Project 86457.02  
14 March 2019  
86457.02.R.001.Rev0  
KDP:mm

**Response to EPA Comments**  
**UNSW D14 Building**  
**High Street, Kensington**

**Addendum to Remediation Action Plan**  
**UNSW D14 Building**  
**High Street, Kensington**

DRAWING  
**SITE BOUNDARIES**  
Sheet 1 of 1

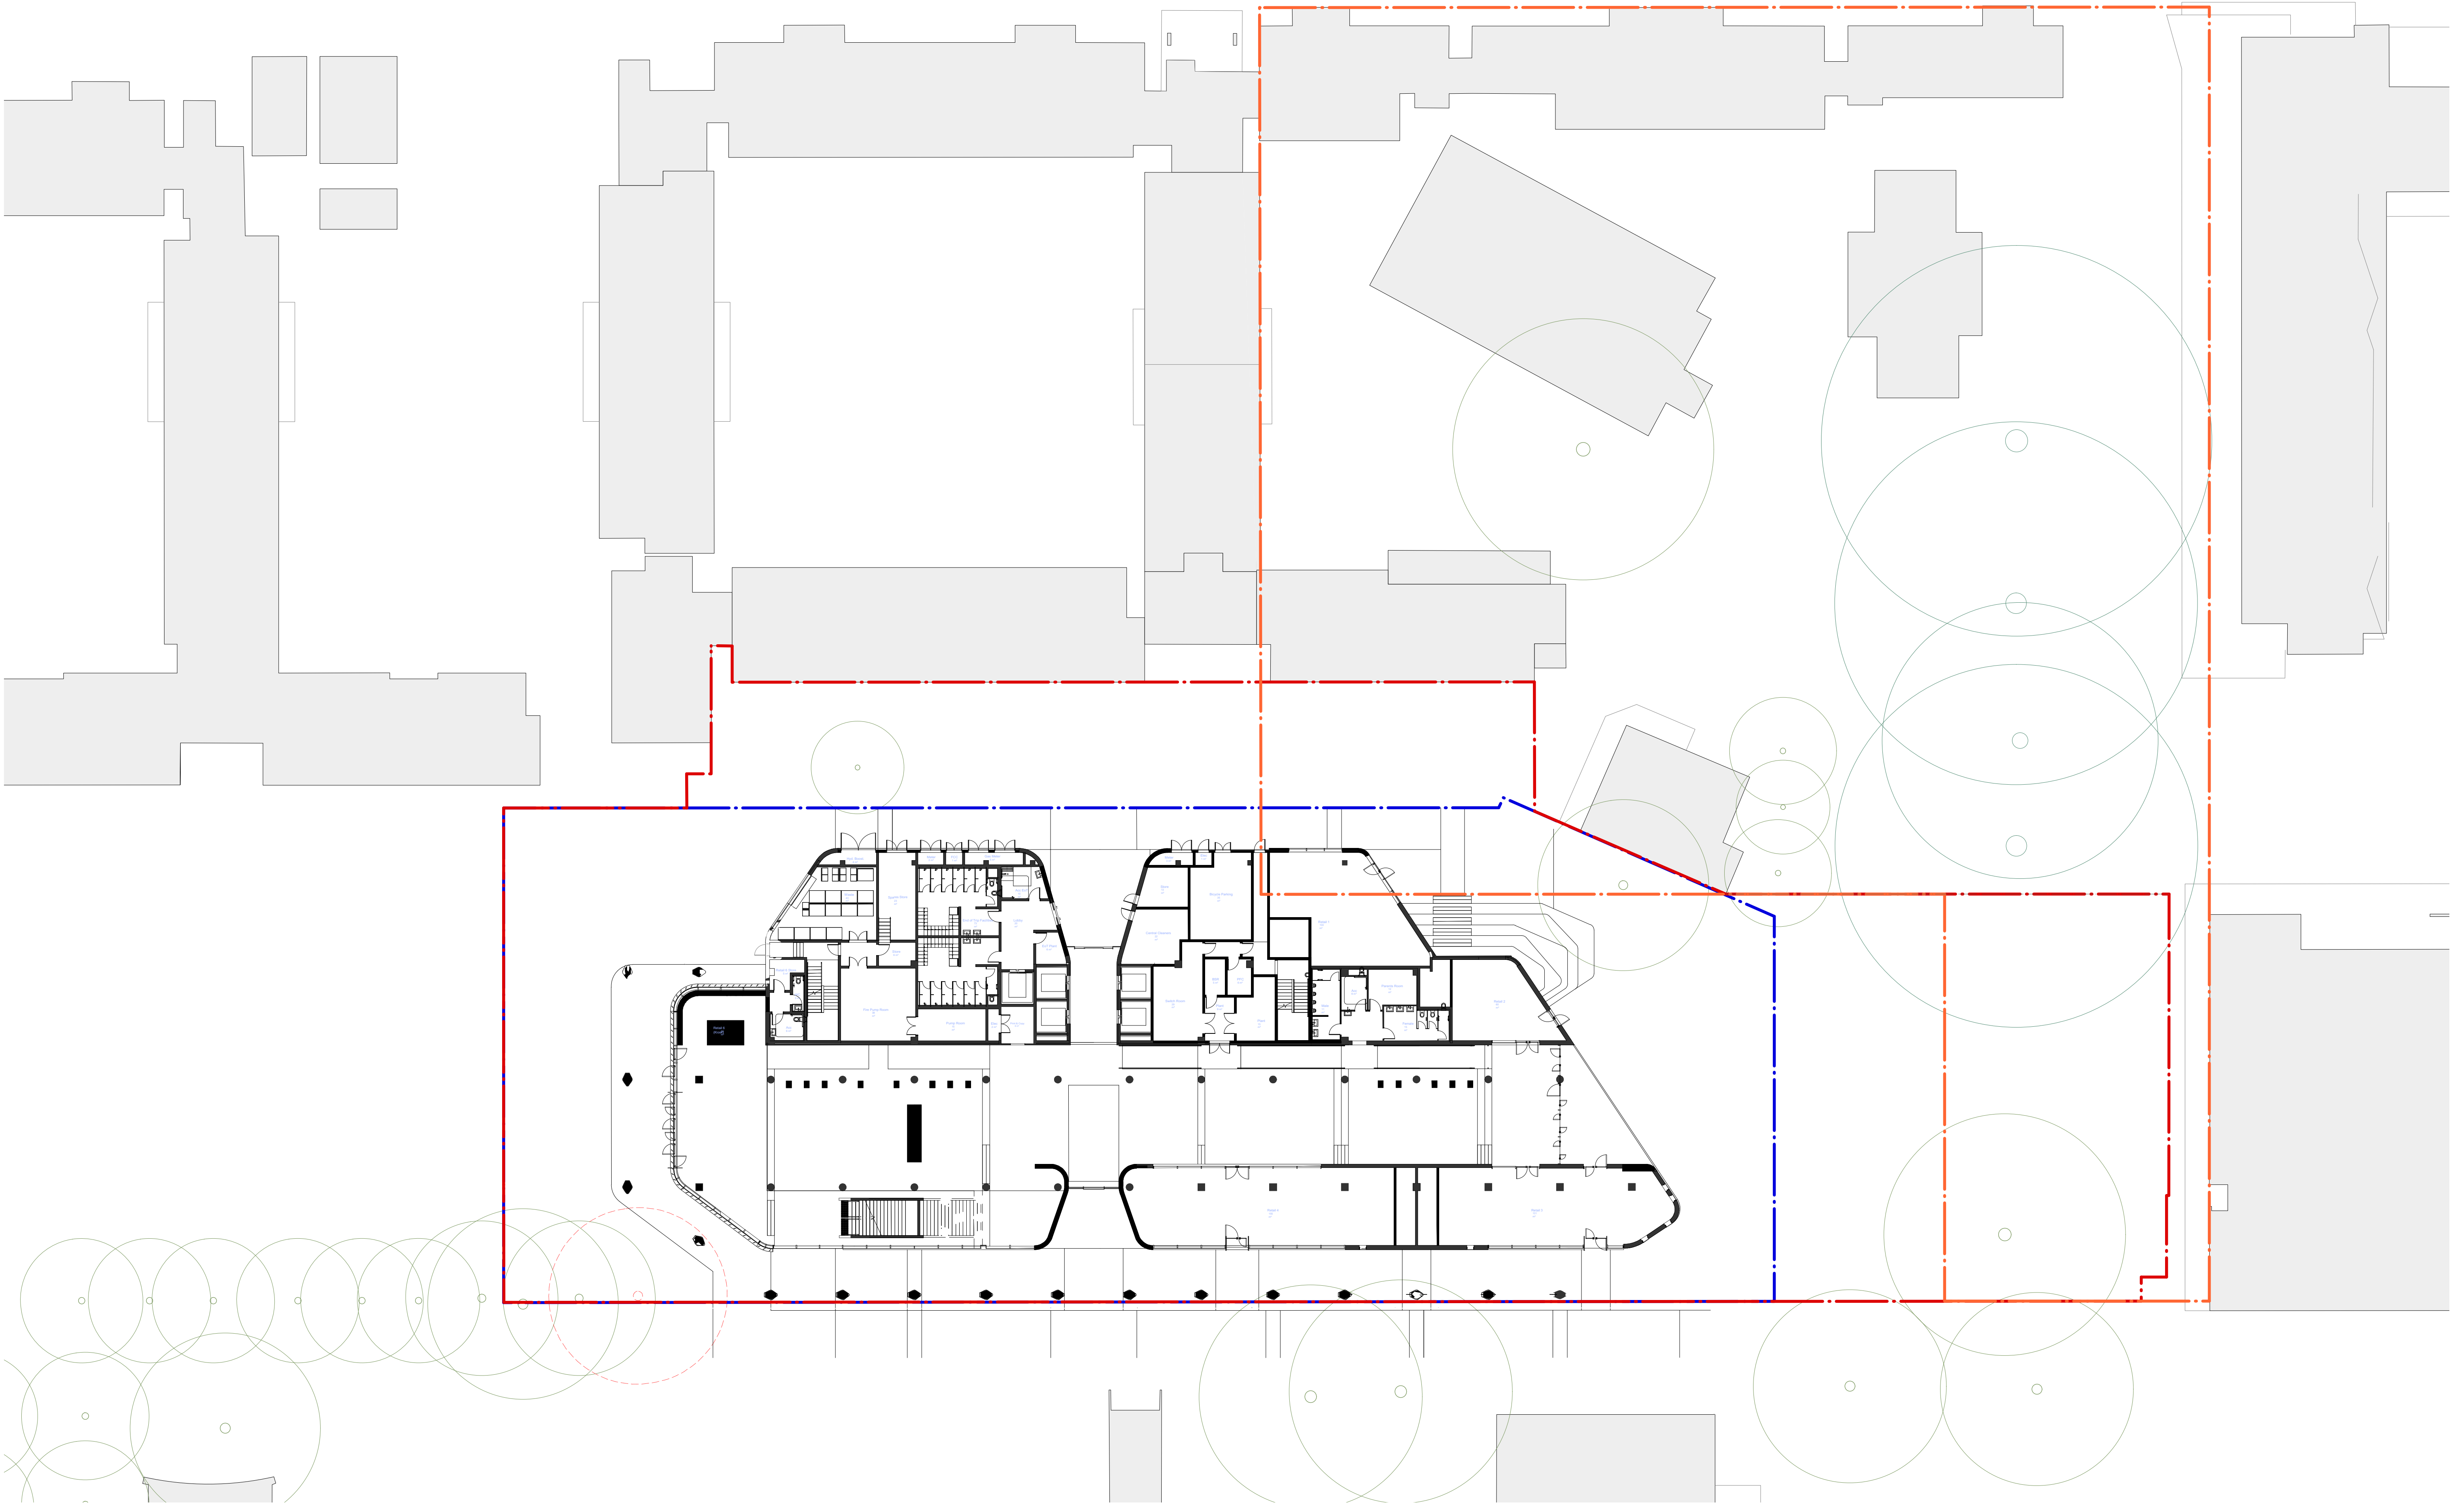
It is understood that the project boundary has been expanded (from the blue hatched, 'Project Boundary' line shown on the attached drawing), primarily to the east to include the Fig Tree Heritage Conservation Area (HCA) (the red hatched boundary, i.e. the 'Make Good Boundary', also shown on the attached drawing). The expanded area increases the site area in the order of 1200 m<sup>2</sup>.

The CA included limited sampling and did not include testing into the expanded area east of the original project boundary (the HCA). It is noted however, that, as the HCA falls within the broader university grounds similar site history and ground conditions would be expected within HCA and therefore the broad contaminant risks and conceptual site model would be similar to those identified in the CA for the original project boundary. As such the conclusion of the CA that the risk of contamination would be low

would also generally apply to the HCA. However, due the limited intrusive investigations, it is considered appropriate to expand the data gap assessment specified in Section 9.3.1 of the RAP to include the portion of the HCA that falls within the expanded project boundary.

Accordingly, the revised data gap assessment in the HCA shall (in addition to the data gap assessment detailed in the RAP) include:

- A review of the site history information in the CA including a review of the aerial photographs to identify potential contaminant risk;
- A site walkover to identify current site features and visually apparent areas of environmental concern. This will be conducted prior to drilling / test pitting to identify areas of environmental concern (AECs) to be targeted during sampling;

- Excavation of five test pits to a depth of 1.5 m to 3.0 m or prior refusal using an excavator. Test bores may be drilled in lieu of test pits near tree roots to prevent damage to the trees. Collection of soil samples at regular intervals;
